ADDENDUM #1

City of Berea Restroom

BG 24-016

DATE: September 23rd, 2025

FOUNDATION PLAN

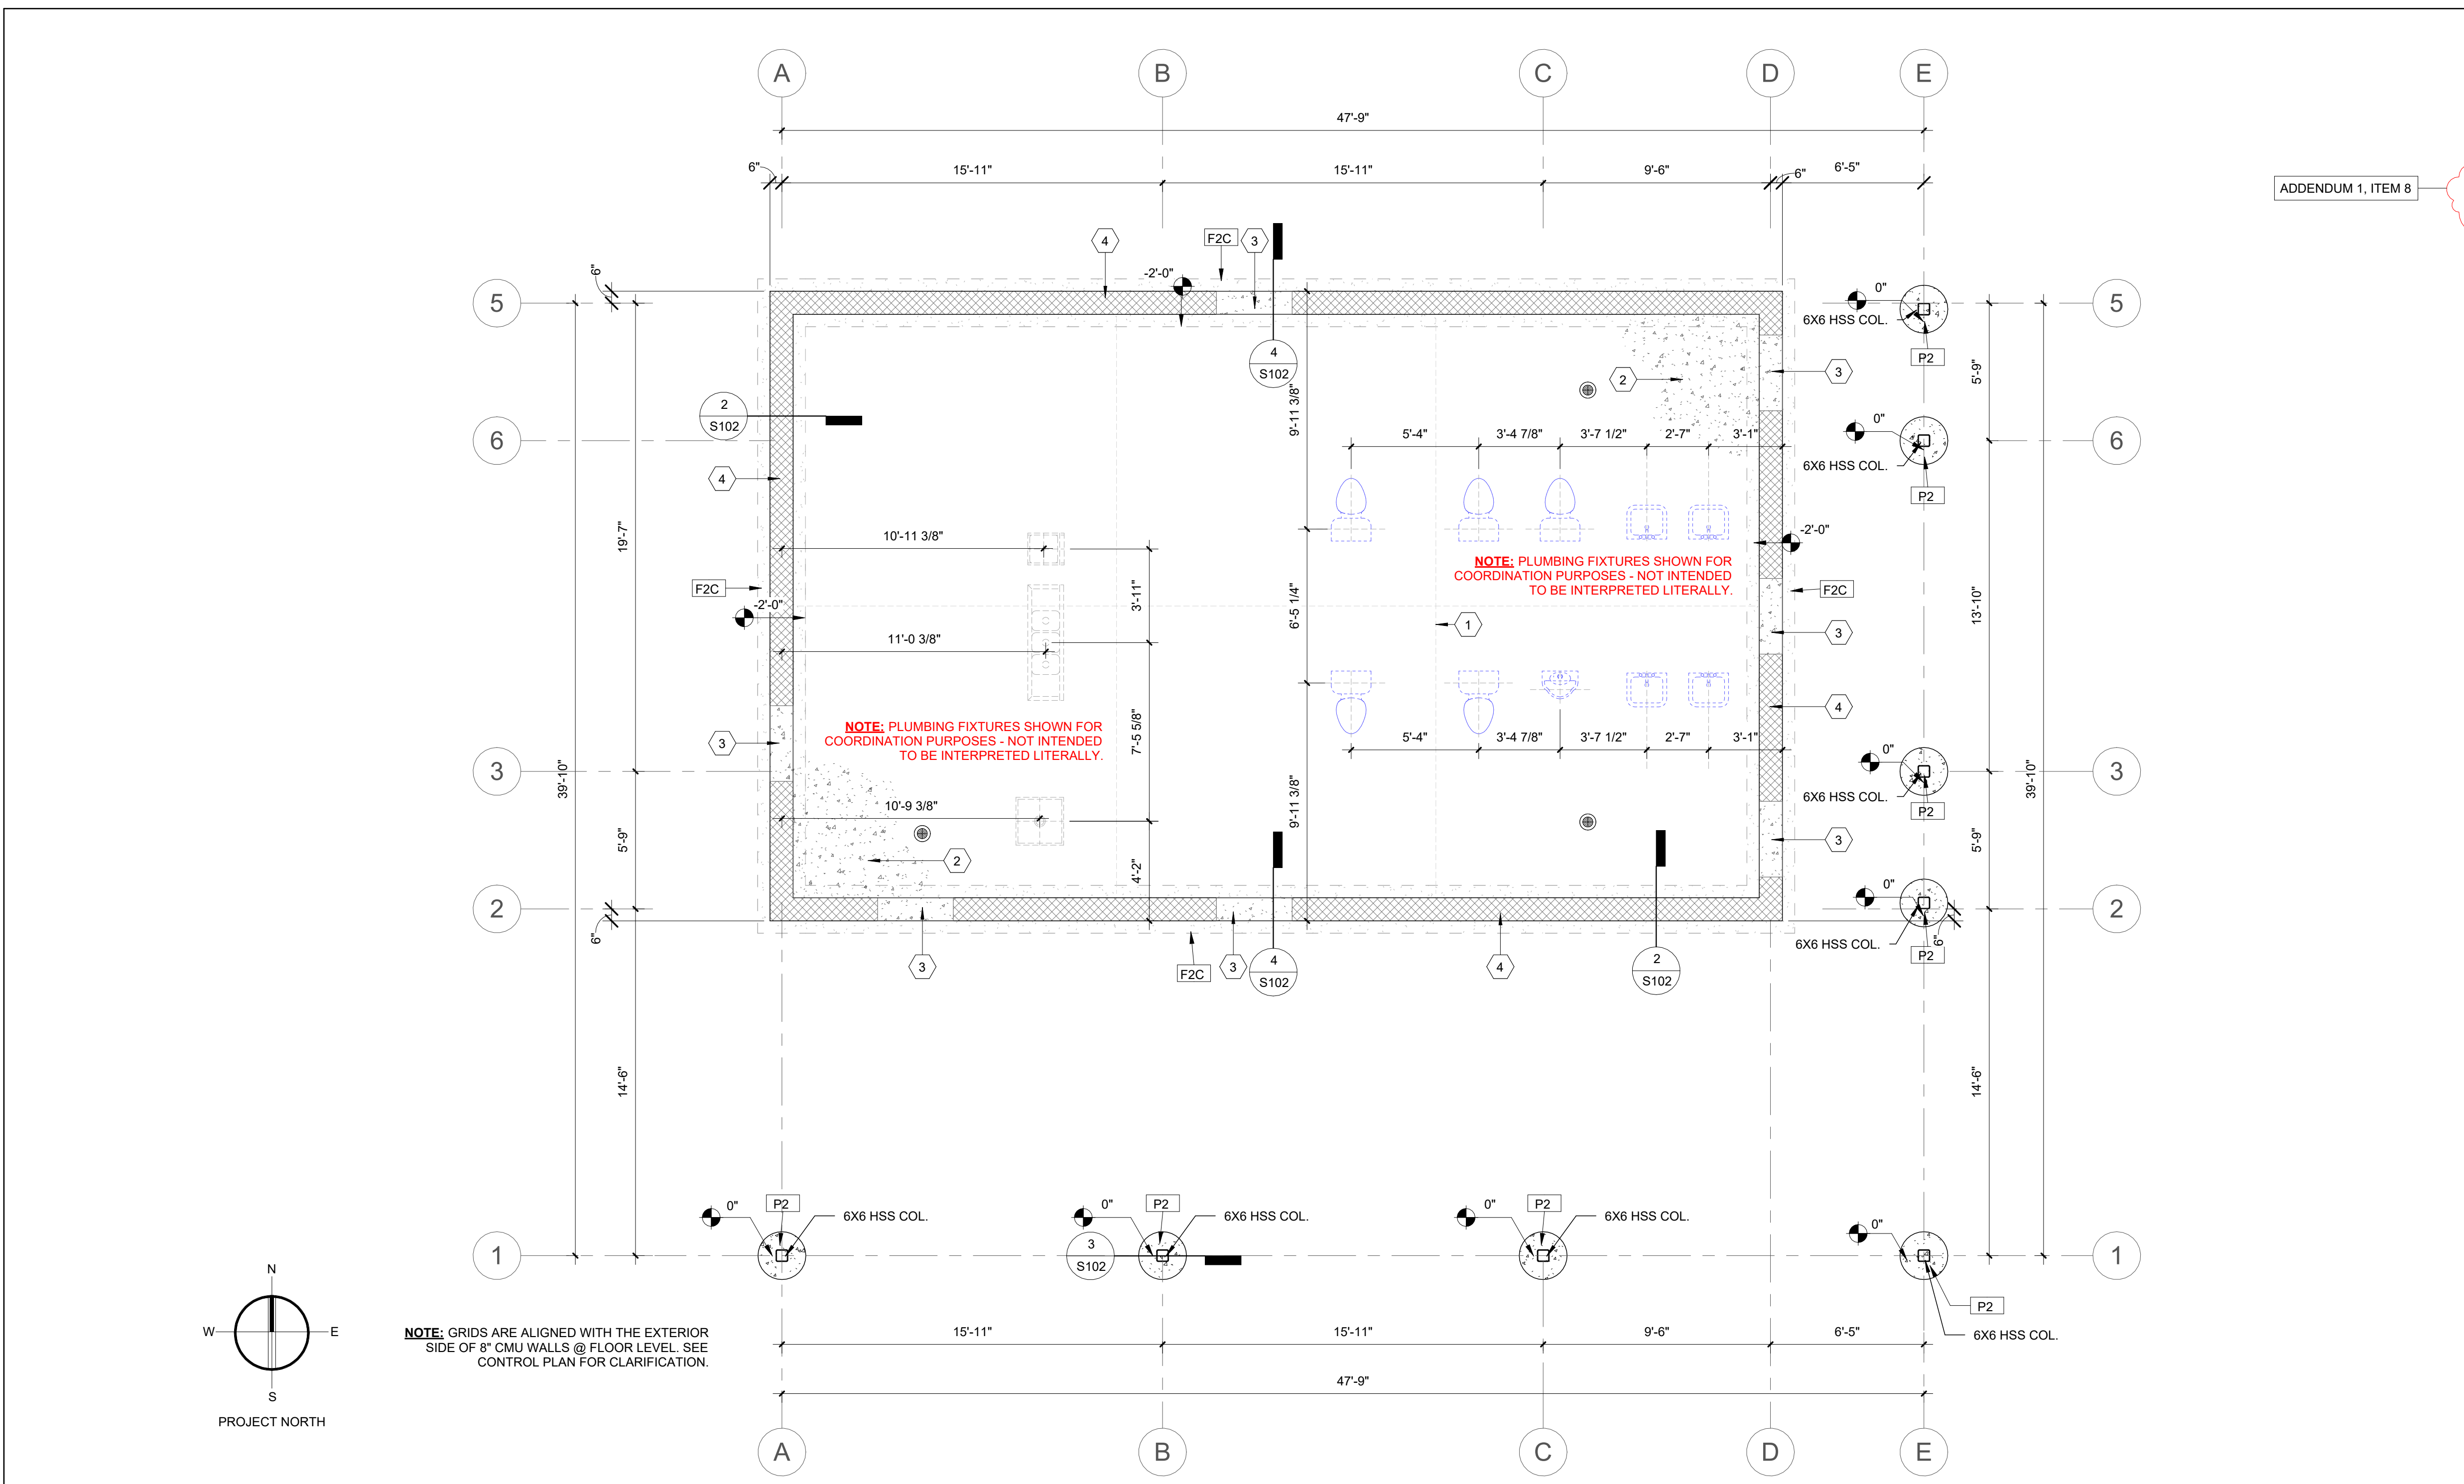
- 8. Refer to attached sheet S102; Sheet Notes – FOUNDATION
 - a. Sheet note 4 will now read: 8" CMU + 6" CMU STEM WALL SLUSHED FULL
- 9. Refer to attached sheet A101; WALL TYPE LEGEND

SHEET NOTES - FOUNDATION	
NOTE NUMBER	DESCRIPTION
1	SAW JOINTS NOT TO EXCEED 15'-0" IN EITHER DIRECTION
2	4" CONCRETE SLAB W/ 2.9X2.9 WWR OVER 6 MIL VAPOR BARRIER OVER 8" CRUSHED STONE. PROVIDE 1/2" EXPANSION JOINTS AT STEM WALLS
3	BLOCK OUT STEM WALL @ DOOR THRESHOLD. POUR SLAB THROUGH & TURN DOWN SLAB @ DOOR THRESHOLD
4	8" CMU + 6" STEM WALL SLUSHED FULL

A101

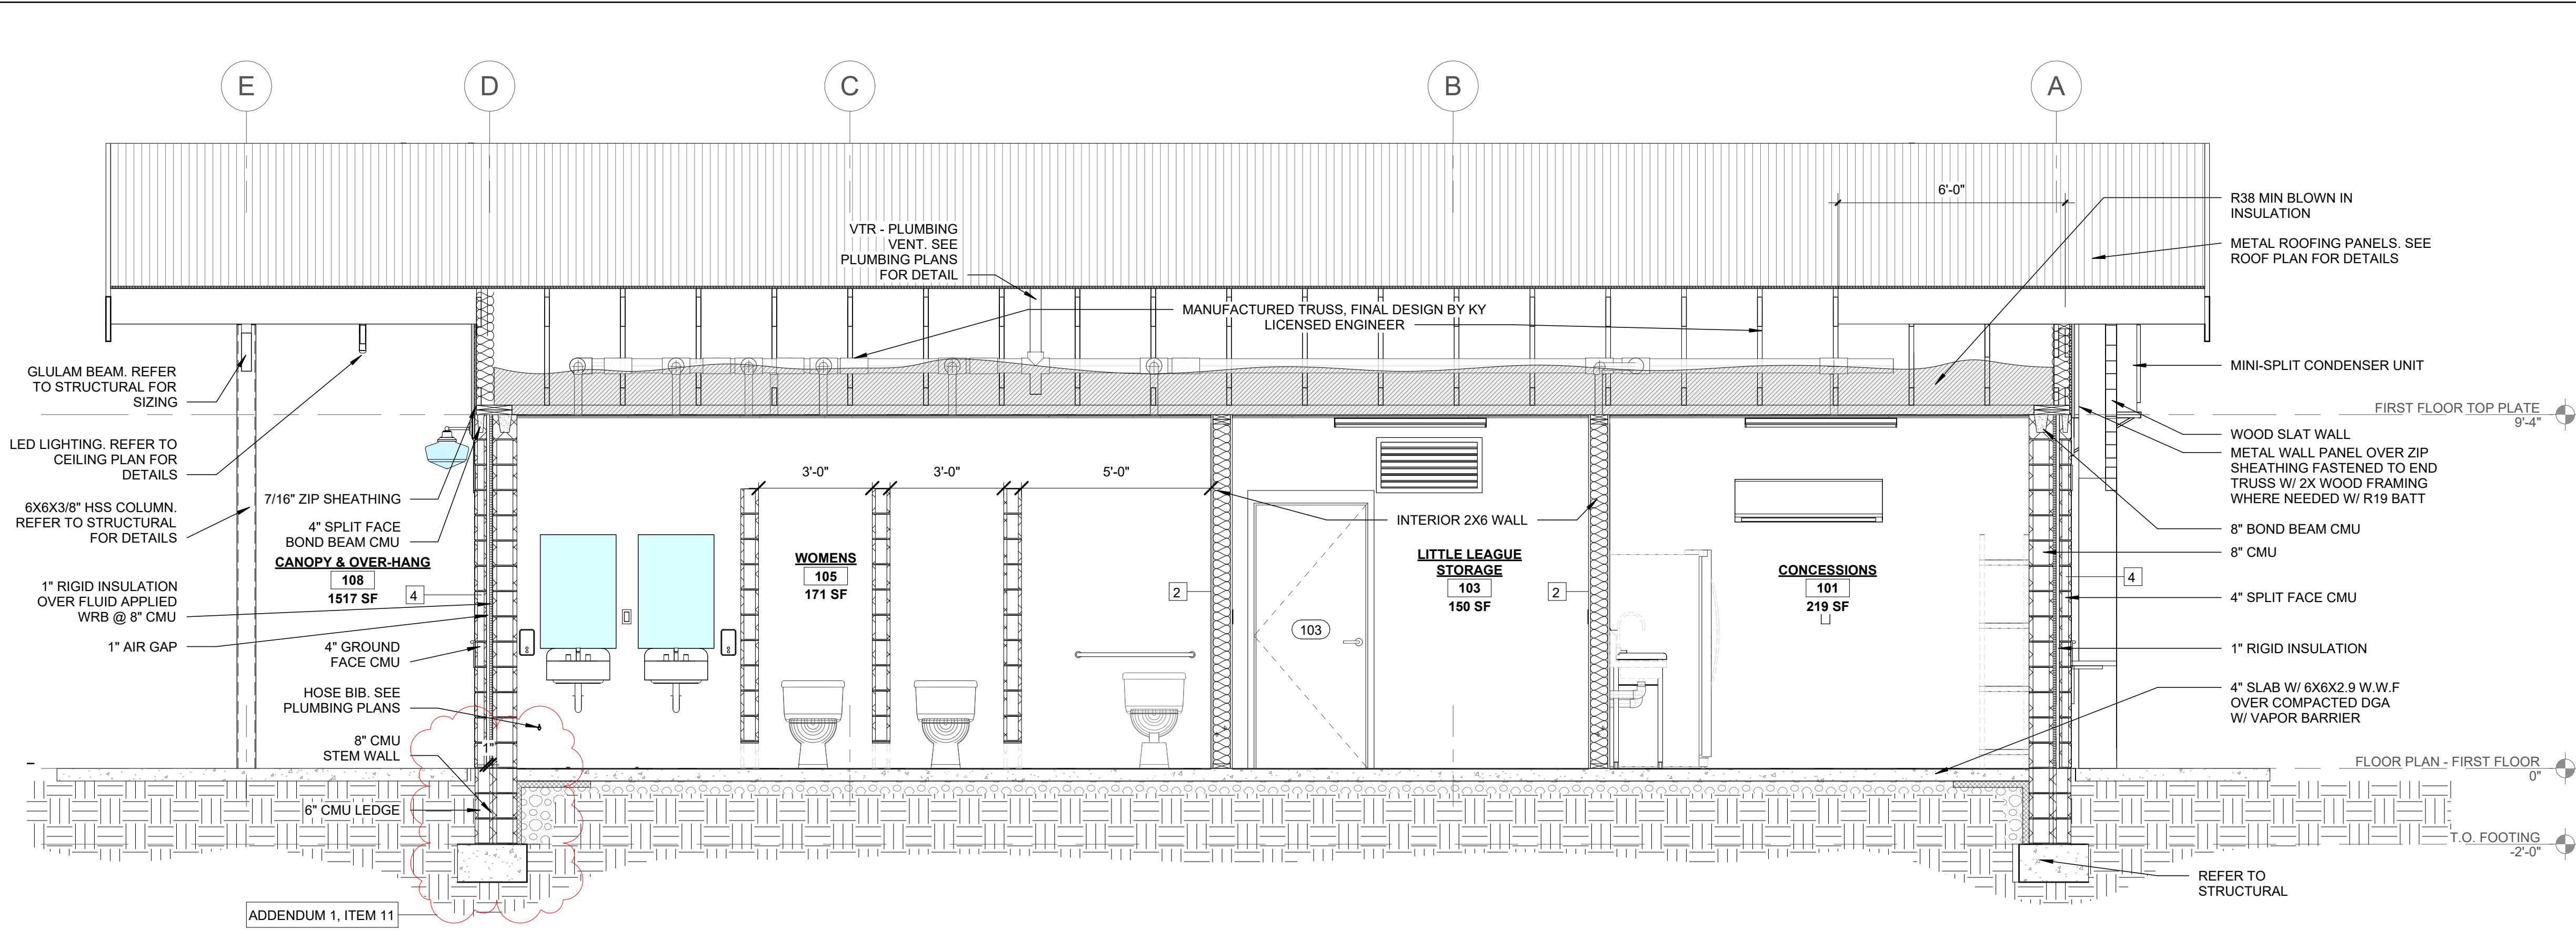
1. Refer to attached sheet A101; Sheet Notes – Floor Plan
 - a. Sheet note 2 will now read: WATER HEATER – TANK TYPE – RHEEM
2. Refer to attached sheet A301; Wall Section & Details – 7- Restroom Gender Sign
 - a. Sheet detail view 7 will show Restroom Gender Sign with dimensions.
3. Refer to attached sheet M100; HVAC PLAN NOTES

- a. Wall type 3 will now read; 6" CMU
- 10. Refer to attached sheet A101; WALL TYPE LEGEND
 - a. Wall type 4 will now read; 4" SPLIT FACE CMU, 1" RIGID INSULATION OVER FLUID APPLIED WRB, 8" CMU

INTERIOR		5/8" GWB
WALL TYPE 1		2X4 WOOD STUD
INTERIOR		5/8" GWB
INTERIOR		5/8" GWB
WALL TYPE 2		2X6" WOOD STUD
INTERIOR		5/8" GWB
INTERIOR		6" CMU
WALL TYPE 3		
INTERIOR		
EXTERIOR		4" SPLIT FACE CMU
WALL TYPE 4		1" RIGID INSULATION OVER FLUID APPLIED WRB
INTERIOR		8" CMU
INTERIOR		EXTERIOR METAL WALL PANEL
WALL TYPE 1		2X4 WOOD STUD
INTERIOR		
INTERIOR		EXTERIOR METAL WALL PANEL
WALL TYPE 1		2X6 WOOD STUD
INTERIOR

1 BUILDING SECTION - LONGITUDINAL
3/8" = 1'-0"

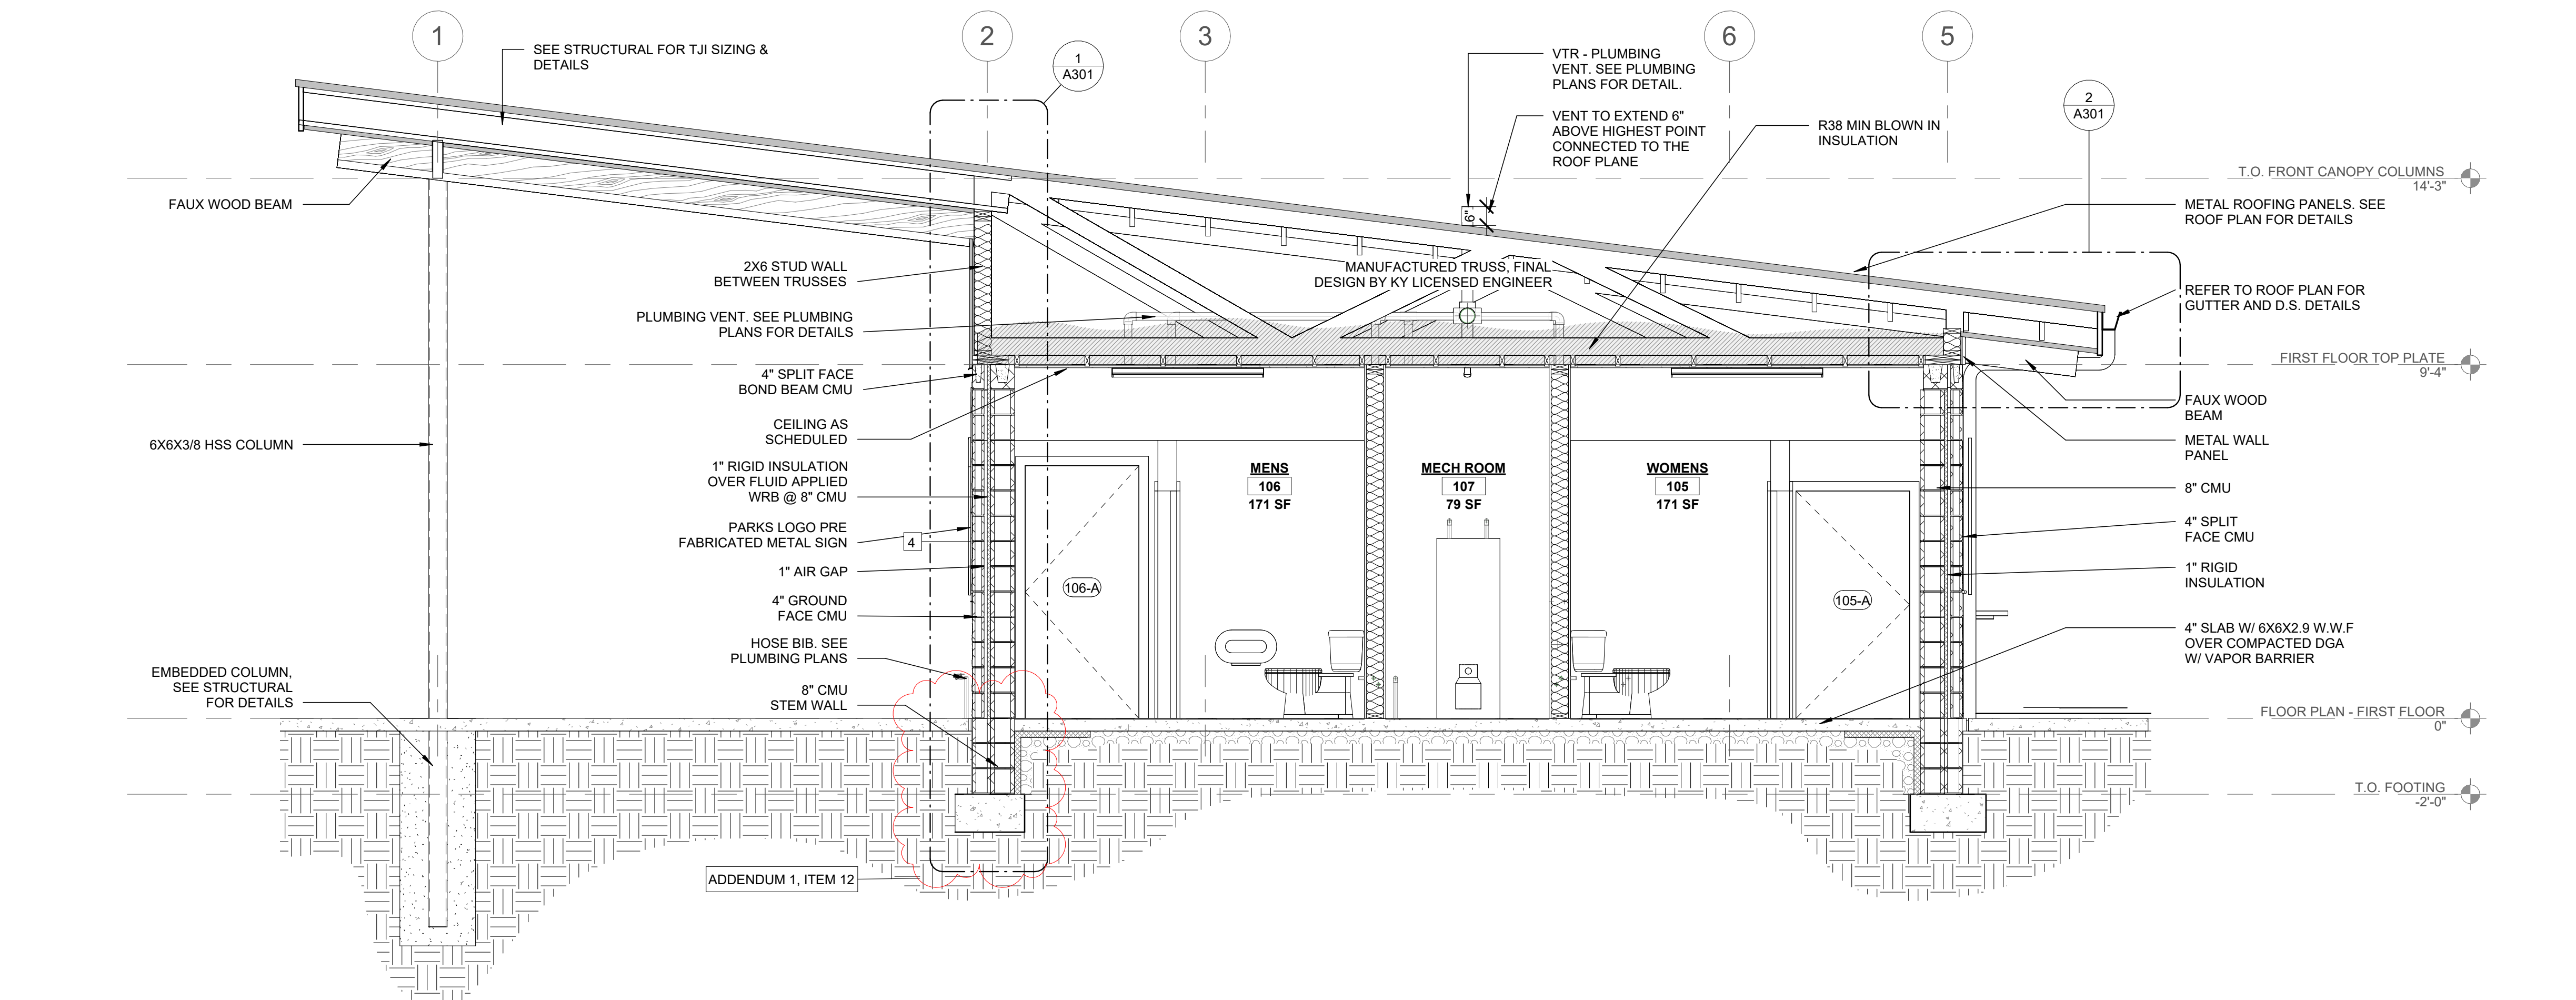
- 11. Refer to attached sheet A300; BUILDING SECTIONS
 - a. Building Section – Longitudinal now shows 6" CMU LEDGE WITH 8" STEM WALL
- 12. Refer to attached sheet A300; BUILDING SECTIONS
